**CITY PLAN COMMISSION****THURSDAY, OCTOBER 19, 2023****FILE NUMBER:** S223-261**SENIOR PLANNER:** Sharmila Shrestha**LOCATION:** C F Hawn Freeway, northeast of Kleberg Road**DATE FILED:** September 22, 2023**ZONING:** CS**CITY COUNCIL DISTRICT:** 5**SIZE OF REQUEST:** 3.580-acres**APPLICANT/OWNER:** Jordan Langston**REQUEST:** An application to create one 3.580-acre lot from a tract of land in City Block 8793 on property located on C F Hawn Freeway, northeast of Kleberg Road.**SUBDIVISION HISTORY:**

**PROJECT:** PRELIMINARY PLAT  
 VAILT ADDITION  
 LOT 1, BLOCK 8793  
 BENEFIT OF CALLETS 3.580 ACRES OF LAND  
 SITuated IN  
 THE McDONALD WILSON SURVEY  
 DALLAS COUNTY, TEXAS

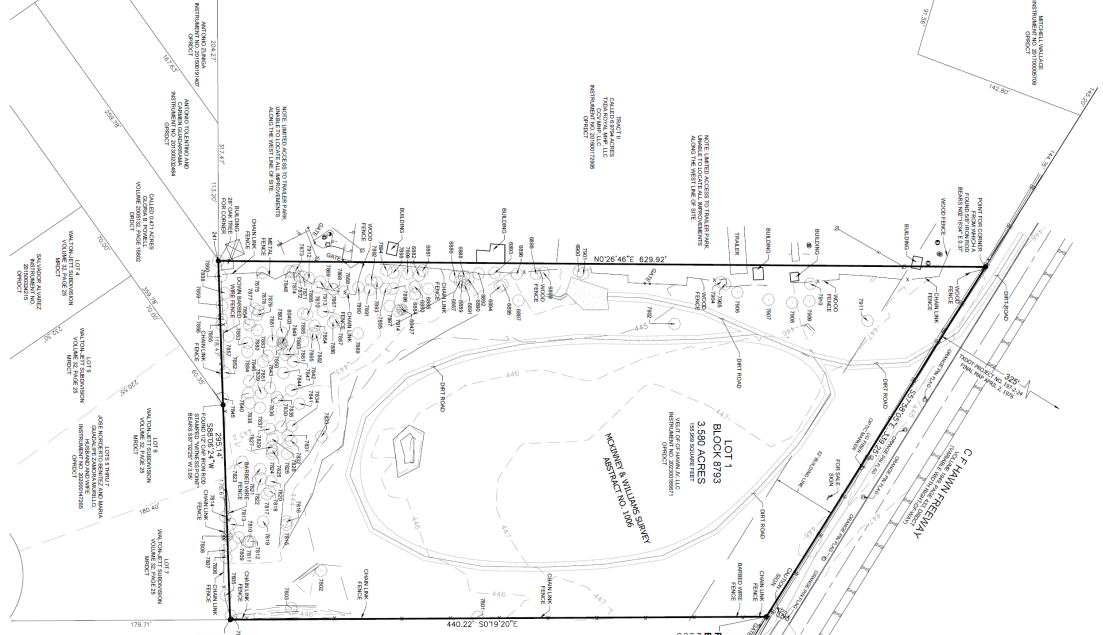
1. The final plat must conform to all requirements of the Dallas Development Code, Texas Local Government Code, Texas Land Surveying Practices Act and the General Rules and Regulations of the Texas Board of Land Surveying.

2. Department of Development Services, Engineering Division must verify that the plat conforms with the water, wastewater, and easement requirements under the provisions of Chapter 49 of the Dallas City Code.

3. Compliance with all plans, contracts, ordinances, and requirements of the City of Dallas. *Section 51A-8.102(a), (b), (c), and (d)*
4. The number and location of fire hydrants must comply with the Dallas Fire Code.

5. Any new or existing structure may not extend across new property lines. *Section 51A-8.503(e)*
6. On the final plat, all easement abandonments, and ROW abandonments must be by separate instrument with the recording information shown on the face of the

7. On the final plat, include two boundary corners tagged with these coordinates: "Texas State Plane Coordinate System, North Central Zone, North American Datum of 1983 on Grid Coordinate values, No Scale and no Projection."

8. On the final plat, monument all set corners per the Monumentation Ordinance. Prior to submittal of the final plat for the Chairman's signature. The monuments must be verified by the Chief City Surveyors Office in the Public Works Department. *Section 51A-8.617*

10. Prior to the final plat, submit a tree survey to the Arborist. A release from the arborist is required prior to an early release request or the recordation of the plat, whichever occurs first.

11. The number of lots permitted by this plat is one.

12. Submit a full set of Civil Engineering Plans (drainage, paving, street signage/markings/lighting) prepared per City Standards by a licensed (TX) Professional Engineer to Engineering Division in Room 200, Oak Cliff Municipal Center (i.e. 311T/DP). Additions and alterations to the public infrastructure require approval and may require private development contracts with bonds. 51A-8.102 (c); 8.601(b)(4),(5),(6),(7),(8),(9)
13. Detention may be required if the capacity of available outfall is not adequate to carry the developed runoff. Section 51A-8.611(c).
14. Place a note on the final plat stating "Lot-to-Lot drainage will not be allowed without proper City of Dallas Engineering Division approval" 51A 8.611(e)

15. TxDOT approval may be required for any driveway modifications or new access.

16. Prior to final plat, submit a completed final plat checklist and all supporting documents.
17. On the final plat, show how all adjoining right-of-way was created.
18. On the final plat, show recording information on all existing easements within 150 feet of the property.
19. On the final plat, show distances/width across all adjoining right-of-way.
20. On the final plat, show all additions or tracts of land within 150 feet of property with recording information.

21. Provide an 8.5-inch by 11-inch signed, sealed, and dated survey of all permanent structures less than 5 feet from the proposed plat boundary lines which are not currently shown on preliminary plat.

22. Additional design information is required for assessment. Site plan must be submitted showing proposed development, building finished floor elevation, development, existing mains – including downstream manhole, and proposed water and wastewater service locations. Submit water/wastewater engineering plans to 320 E. Jefferson Blvd., Room 200, Attention: Water and Wastewater Engineering.

23. wastewater main improvements are required by Private Development Contract. Submit water/wastewater engineering plans to 320 E. Jefferson Blvd., Room 200, Attention: Water and Wastewater Engineering.

24. Engineer shall furnish plans for water and sanitary sewer. Developer shall furnish a contract for water and sanitary sewer.
25. Existing and any proposed Water and Wastewater Easements must be shown and/or increased to conform to current design standards. **Notice:** Minimum Dallas Water Utility easement size 20' for one utility and 25' for both water and sewer. Larger diameter or deeper mains may require additional width.

26. On the final plat, change “C F Hawn Freeway” to “C. F. Hawn Freeway/ U.S. Highway No. 175”.
27. On the final plat, identify the property as Lot 1 in City Block D/8793.
